GOVERNMENT OF THE DISTRICT OF COLUMBIA
DEPARTMENT OF TRANSPORTATION

MEMORANDUM

SUBJECT: BZA Case No.19187– 1212-1218 4th Street, NW

Figure 1 Truck Turning Analysis (Source: Gorove/ Slade)

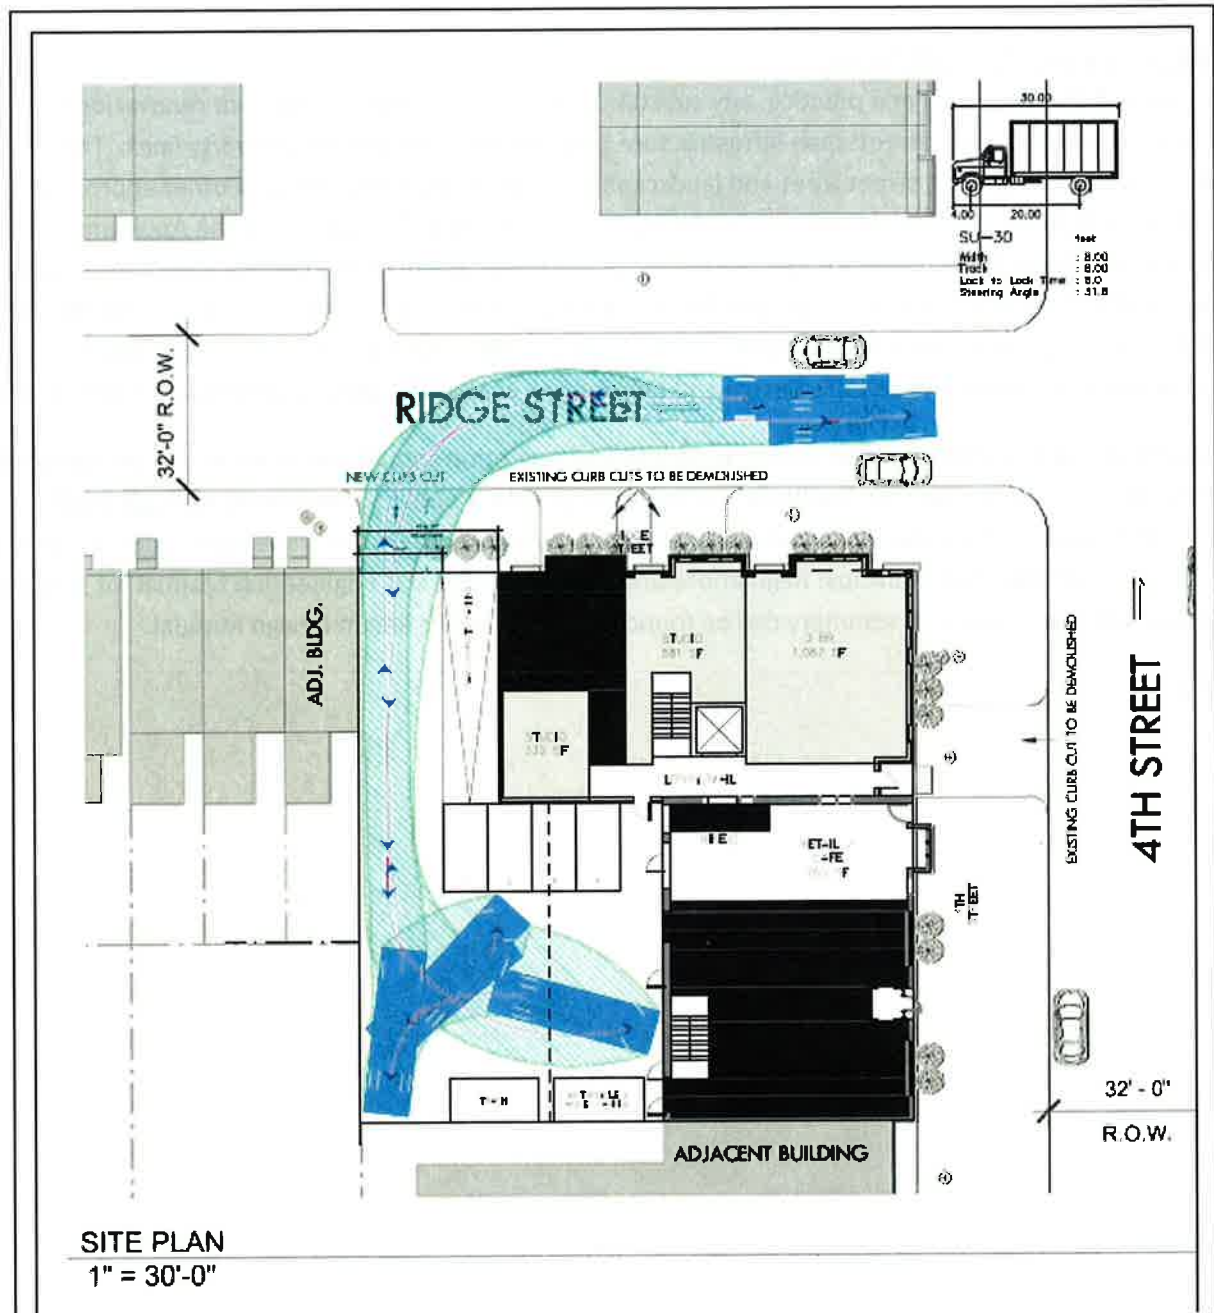
The Applicant proposes trash pick-up to occur in the rear yard via the proposed curb cut off Ridge Street. The Applicant submitted truck turning analysis to DDOT on 3/3/16 that includes truck turning

diagrams showing that truck maneuvers can accommodate movements without backing into public space consistent with DDOT standards.

In addition, the truck analysis diagram showed a revised 25-foot and quarter-inch curb cut in lieu of the 20-foot curb opening showing in the Applicant's drawings submitted on 2/29/16. The 25-foot and quarter-inch curb opening is not consistent with DDOT's minimum standard of 24-feet. The Applicant is expected to continue coordination on the final design of curb cut through DDOT's permitting process.

- The design of bay window and building projections along Ridge Street and 4th Street; and
- The final design of the 25-foot and a quarter-inch curb cut proposed for access to loading and parking from Ridge Street, which exceeds DDOT's 24-foot standard.
